Attn: Mr. Kevin Null  
Subj: Requested Amendment of NRC License Number 21-35144-02

Subj: Requested Amendment of NRC License Number 21-35144-02

# DRAFT Low-Enriched Uranium (LEU) Specifications for Targets

Figure 1. A gamma spectrum from a natural uranium sample (background is subtracted).

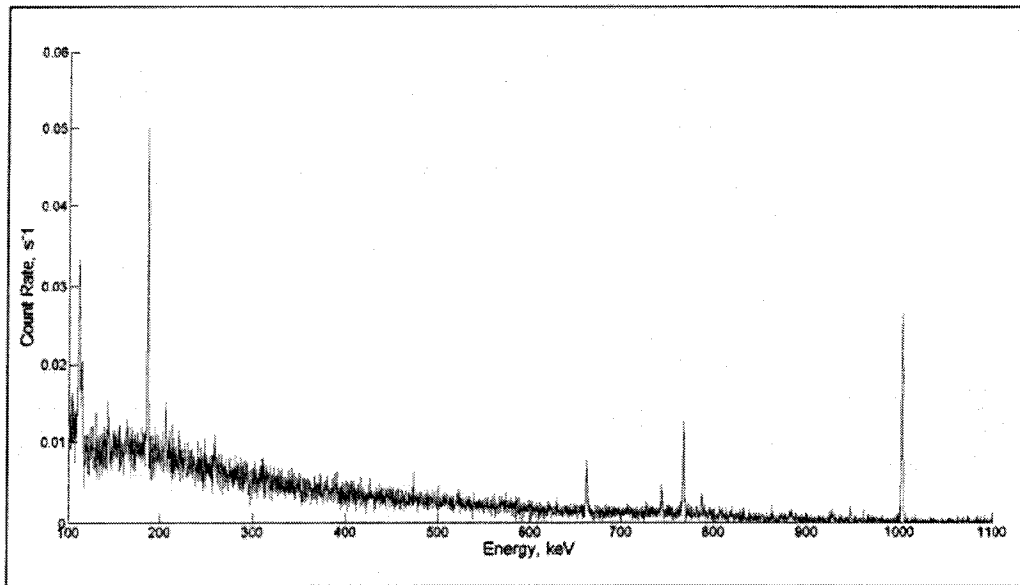
2. Submit procedures that will be implemented to verify that what you receive does not exceed possession limits, or the percent enrichment that you commit to stay within.

To verify the mass of the received material we will be using a calibrated scale. Verification of the enrichment is more complicated and it is described below in details.

Gamma ray analysis for uranium enrichment determination is a rather standard procedure which has been described elsewhere, for example by Clark, 1996. [1]. Niowave has all the necessary equipment for high resolution gamma spectrometry, so the LEU enrichment will be determined by finding the ratio of activities of U-238 and U-235.

As an example of such calculations we performed uranium enrichment determination for some natural uranium samples that we have in stock. Two peaks were used for the calculations: 185.71 keV for U-235 and 1001 keV for U-238. The enrichment was calculated as:

The ratio of activities of U-235 and U-235 was found using Eq. 3. from a gamma spectrum obtained with the HPGe detector setup (see Figure 2).
